SINGLE DIRECTION CURB RAMP

STANDARD PLAN F-40.16-03

SUPPLEMENTAL TO STANDARD PLANS F-40.12-03, F40.14-03, F40.15-04, F40.16-03

Modify the Standard Plan as follows:

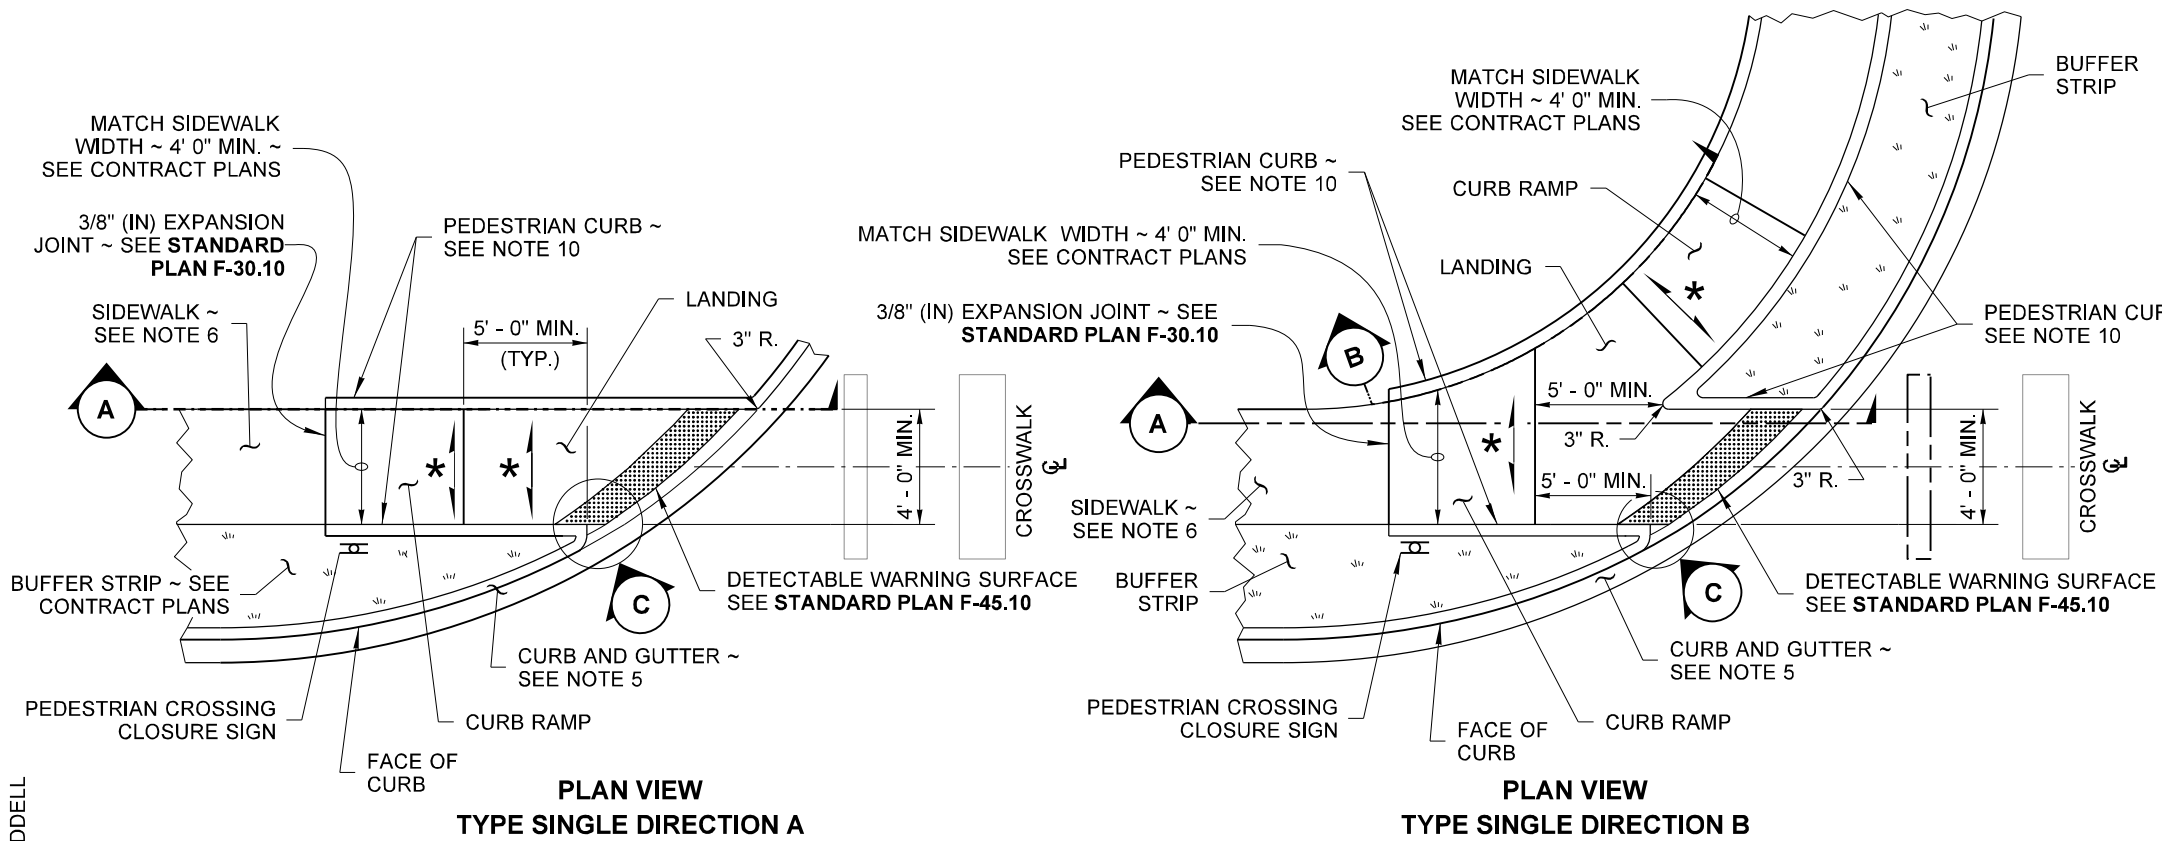
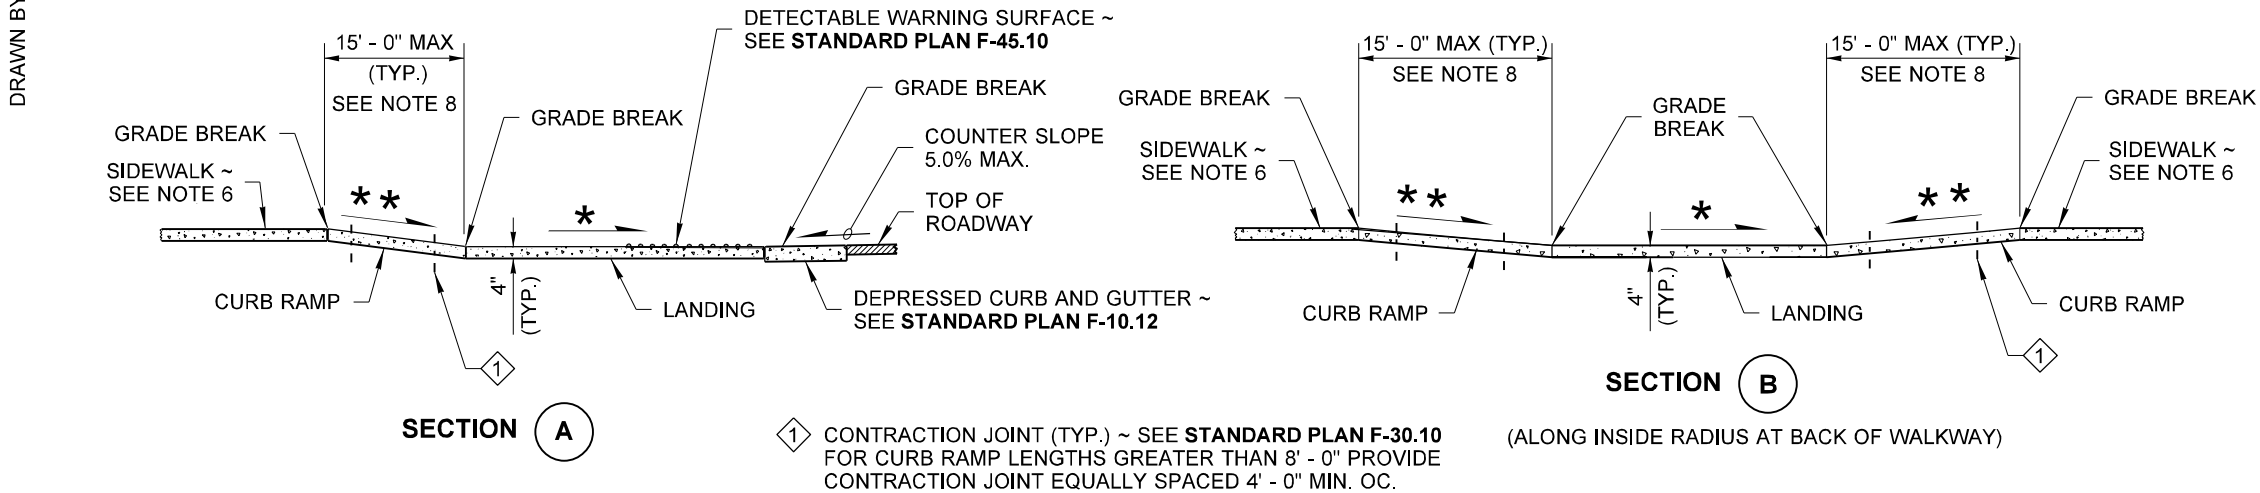
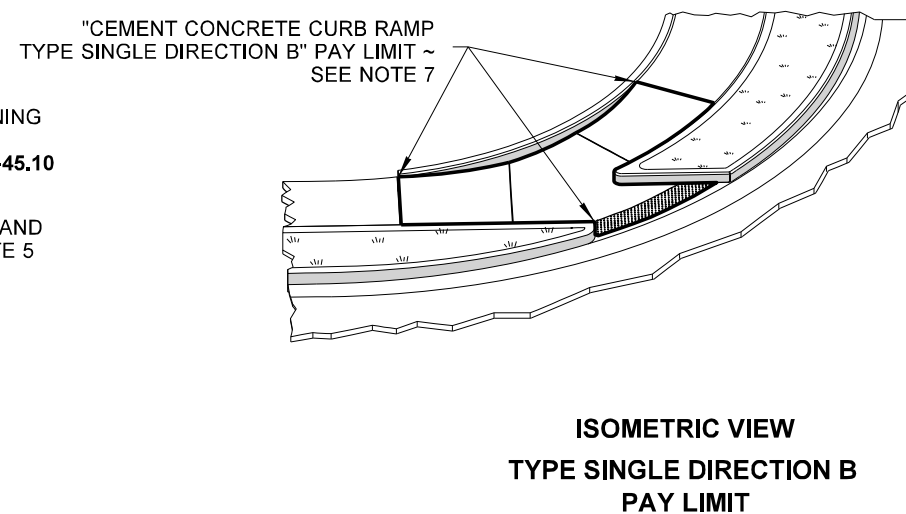
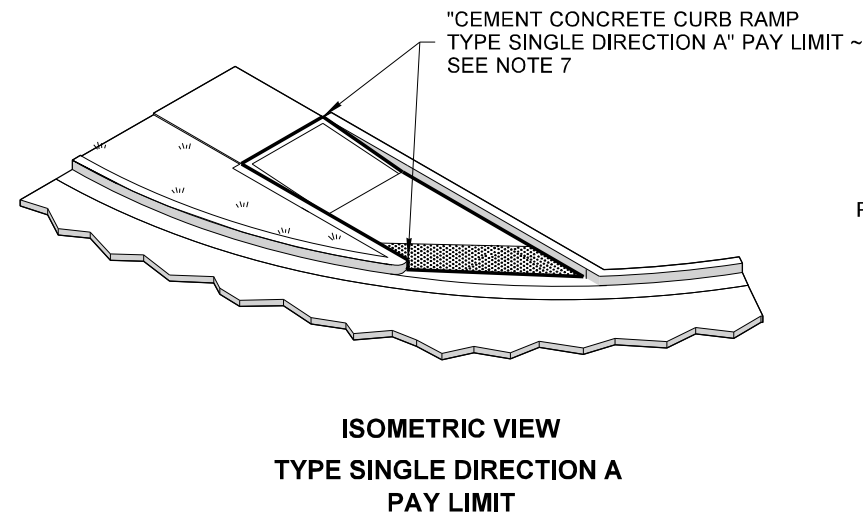
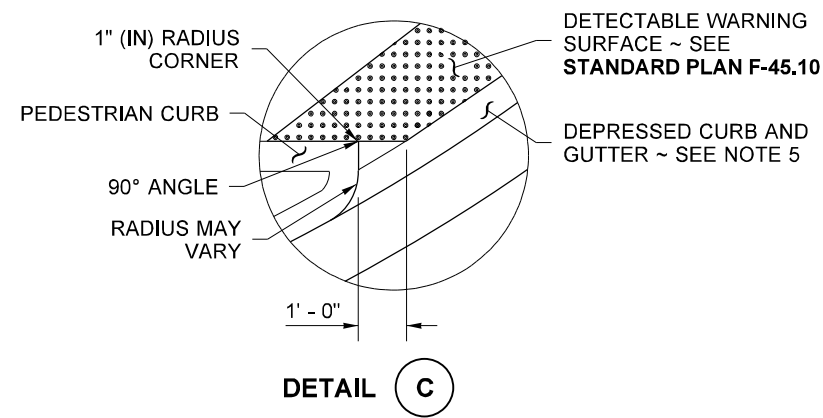
1. Construct a 4" thick layer of compacted CSTC under all concrete.
2. Delete reference to expansion joints in the Standard Plan. Where expansion joints are shown on the Standard Plan construct a contraction joint, except where the new concrete abuts existing construct a construction joint.
3. A raised edge per WSDOT Standard Plan F-30.10-03 may be constructed instead of pedestrian curb.
4. The depressed curb and gutter abutting the width of the curb ramp shall have 0" height.
5. Pay limits for curb ramps are modified to include the pedestrian curb/raised edge, where shown in the plans. The measurement of the area of pedestrian curb/raised edge included in the pay limits will be limited to the surface area of the top of the pedestrian curb/raised edge. Modify note 6 to delete "Pedestrian Curb".
